RS-15-255

R. E. Ginna Nuclear Power Plant  
Renewed Facility Operating License No. DPR-18  
NRC Docket No. 50-244

Subject: Response to NRC Audit Review Request for Additional Information Regarding  
Fukushima Lessons Learned - Flood Hazard Reevaluation Report

**Response to NRC Audit Review Request for Additional Information Regarding  
Fukushima Lessons Learned - Flood Hazard Reevaluation Report**

**Figure 9-8: LIP Time Series Plot for Grid Element 3840 – South of Screen House**

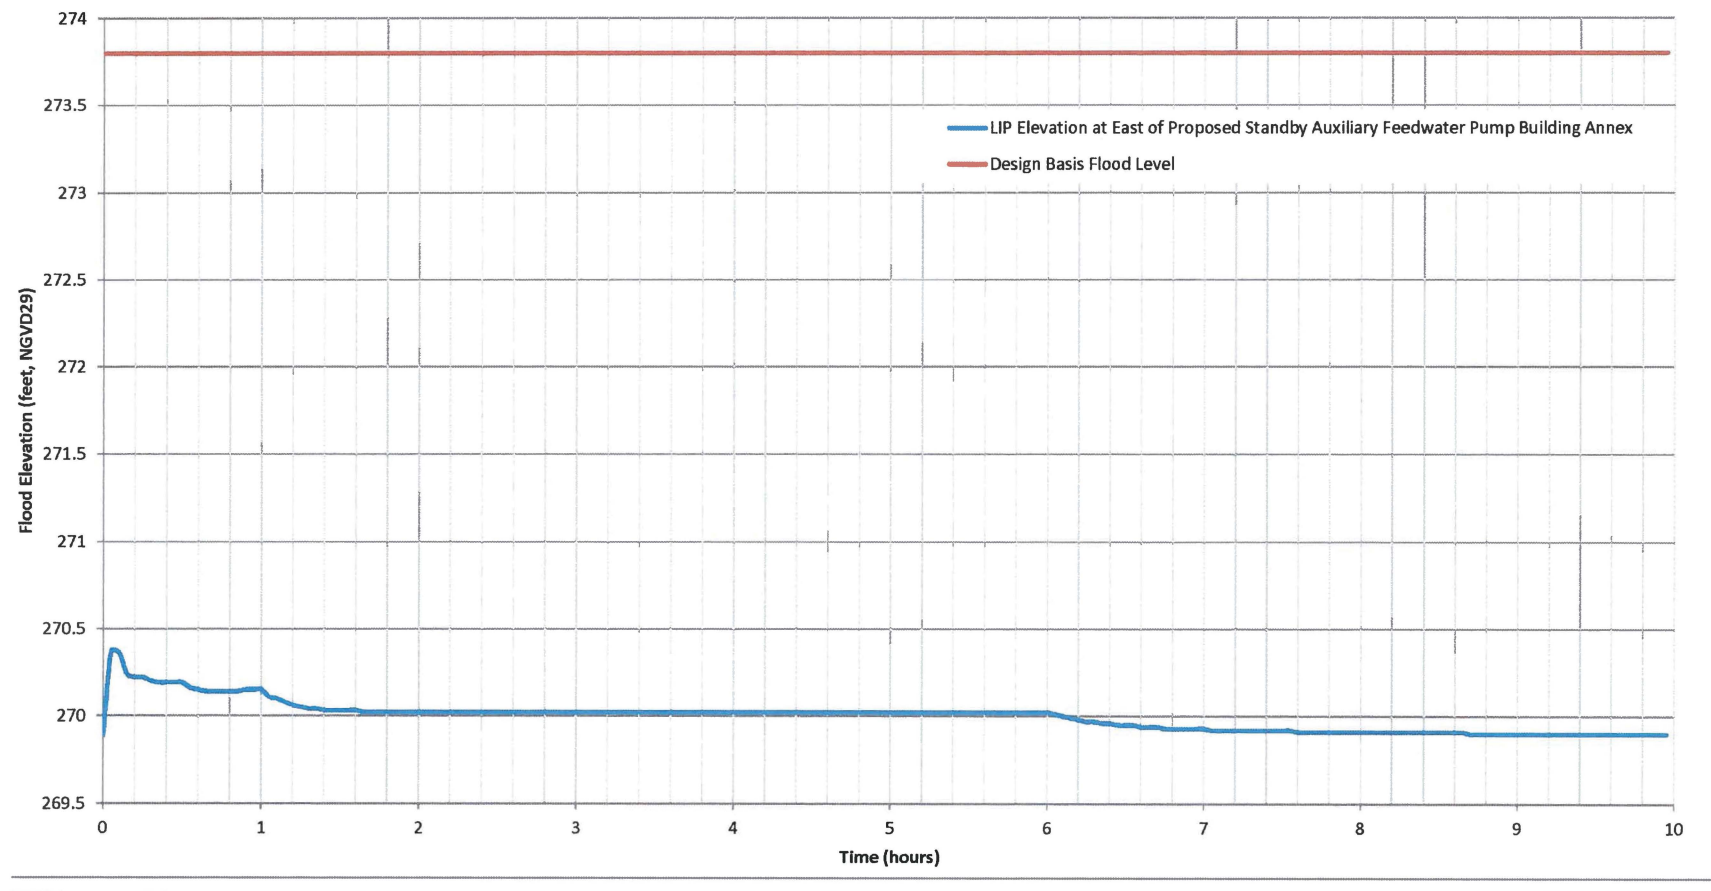
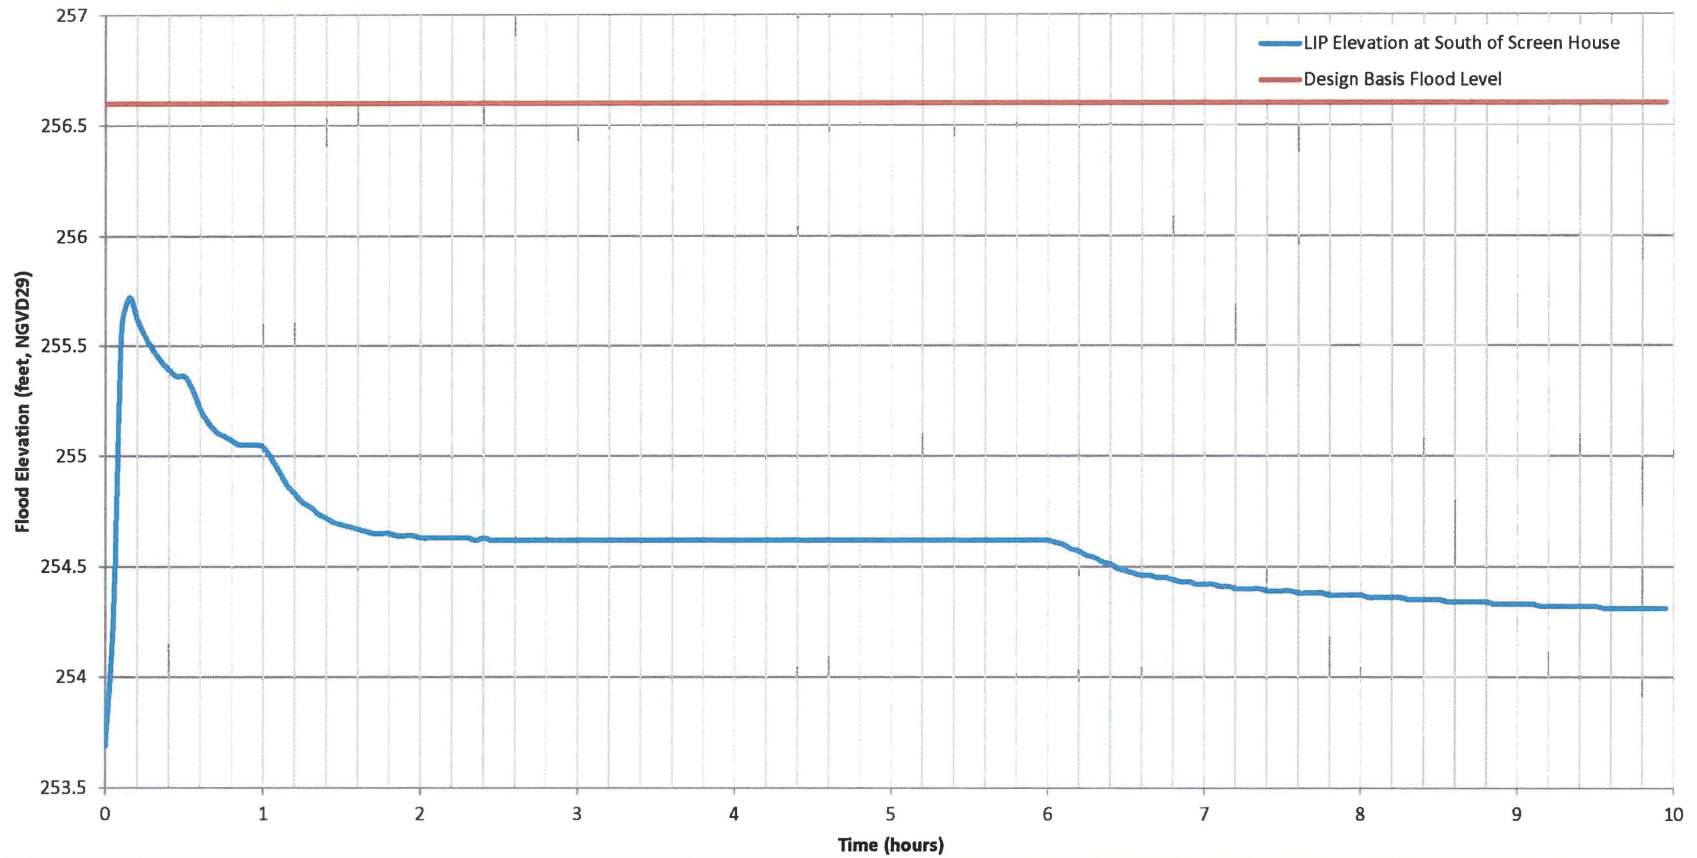
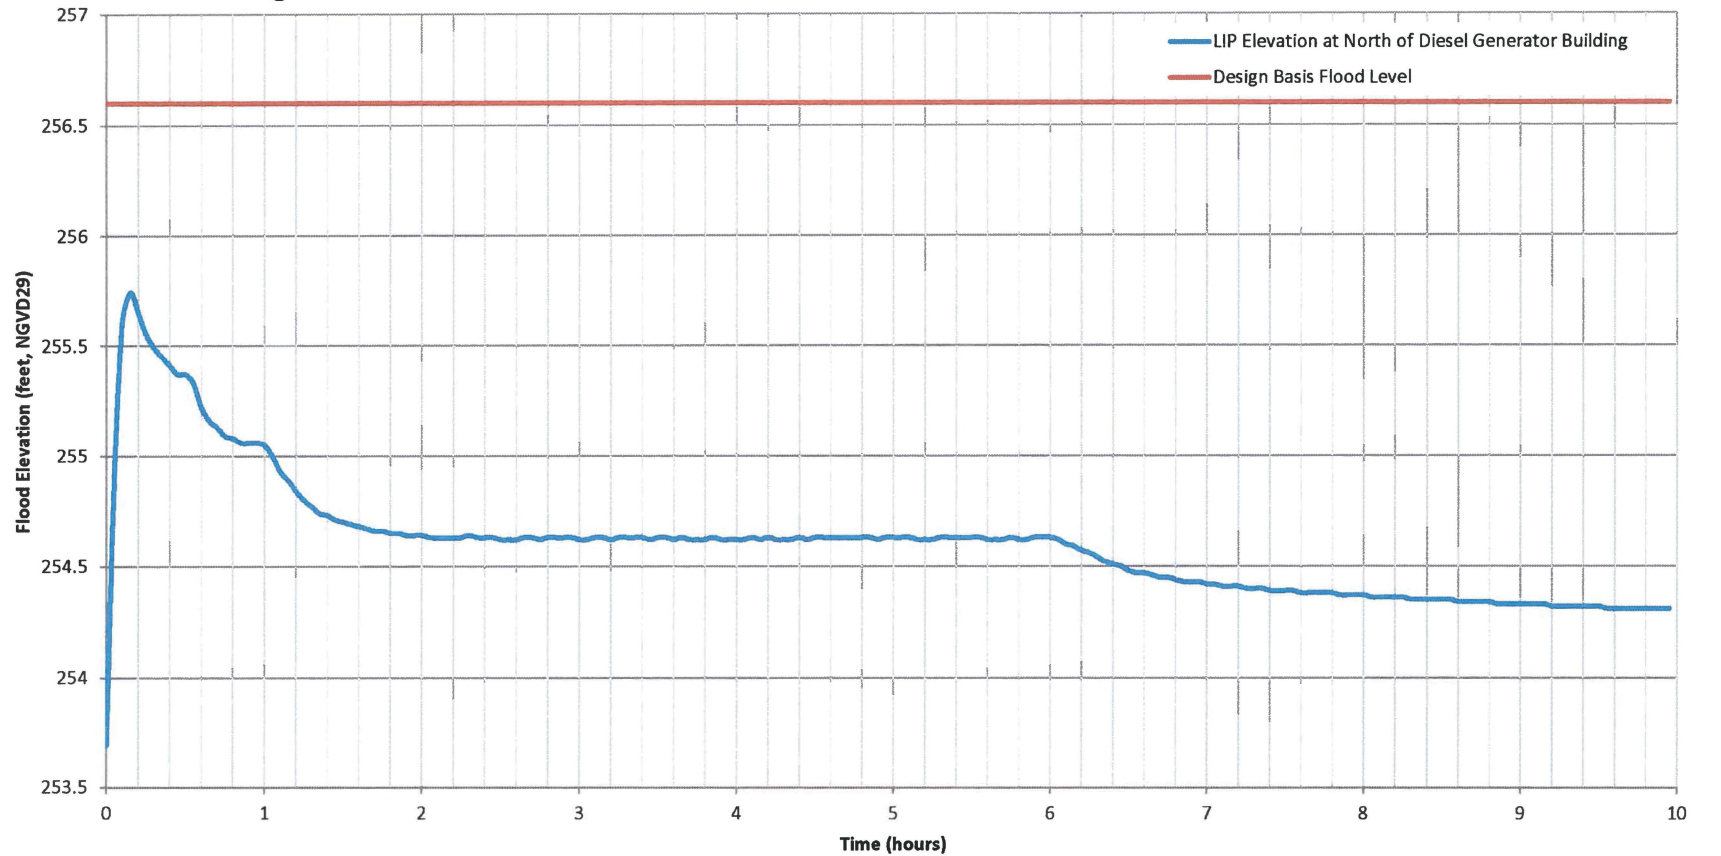
**Request:** *Provide the applicable flood event duration parameters (see definition and Figure 6 of the Guidance for Performing an Integrated Assessment, JLD-ISG-2012-05) associated with mechanisms that trigger an Integrated Assessment using the results of the flood hazard reevaluation. This includes (as applicable) the warning time the site will have to prepare for the event (e.g., the time between notification of an impending flood event and arrival of floodwaters on site) and the period of time the site is inundated for the mechanisms that are not bounded by the current design basis. Provide the basis or source of information for the flood event duration, which may include a description of relevant forecasting methods (e.g., products from local, regional, or national weather forecasting centers) and/or timing information derived from the hazard analysis. The FHRR does state a PMF flood duration (6.5 h) but other parameters are lacking.*

*In Section 3.3 of the FHRR, LIP, flooding on rivers and streams, and two combined-effects flood scenarios were stated to exceed the current licensing basis (which needs to be evaluated/corrected per Information Need #1). The FHRR did not provide sufficiently clear information on all flood duration parameters.*

Time series graphs for the LIP flood mechanism at key locations are provided as Figures 9-1 through 9-9. Time series graphs for the combined effect PMF flood mechanism at key locations are provided as Figures 9-10 through 9-19.

The FHRR indicates flood protection measures described in the FSAR trigger on flood levels at Driveway Bridge. Based on detailed time-series data for the combined effect flood scenario (bounding Deer Creek flooding scenario), there is a 35+ hour delay between the triggering flood levels at Driveway Bridge and flood levels above grade near plant structures.
